**PROJECT:** UMO n HO n Nation Public School - Locker Room Addition – Final Package **DATE:** 23 August 2013

**PROJECT NO.** L13021

## **ADDENDUM #3**

UMO n HO n NATION PUBLIC SCHOOL –  
 LOCKER ROOM / WEIGHTS ADDITION  
 FINAL PACKAGE - ADDENDUM 3

**D1** FRAME DETAIL

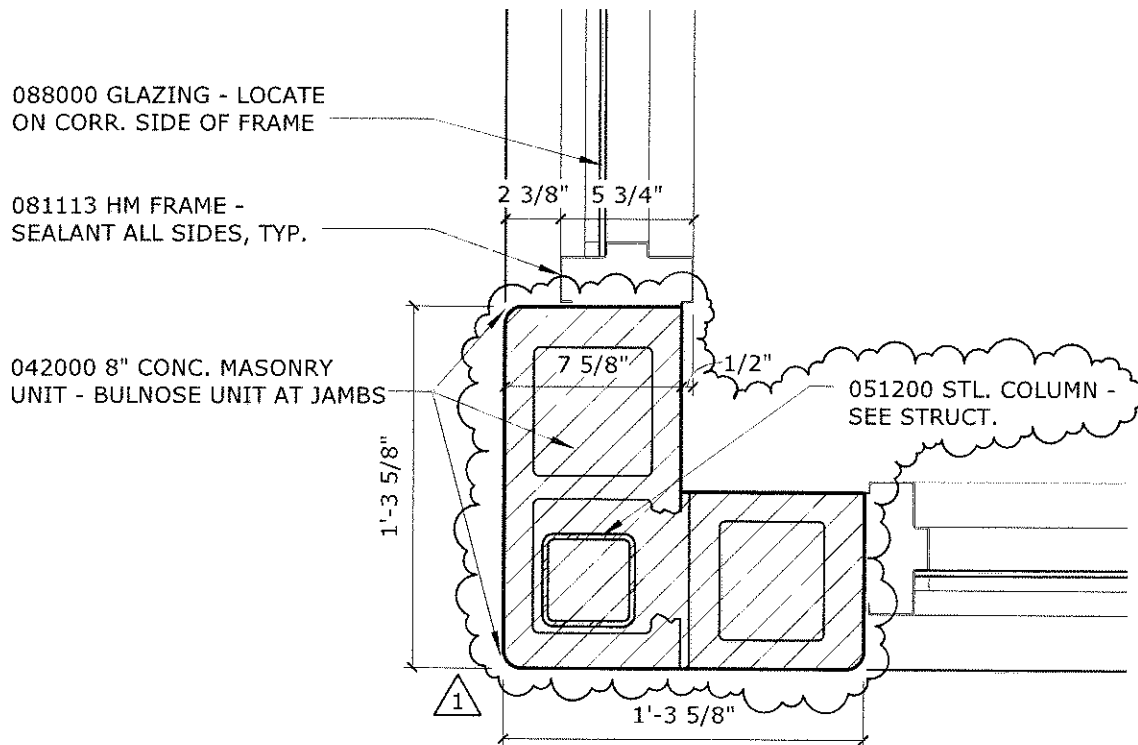
21. Sheet A1.1 – Detail D1/A1.1: Replace Detail D1/A1.1 with revised Detail D1/A1.1 per attached Drawing ASD-01
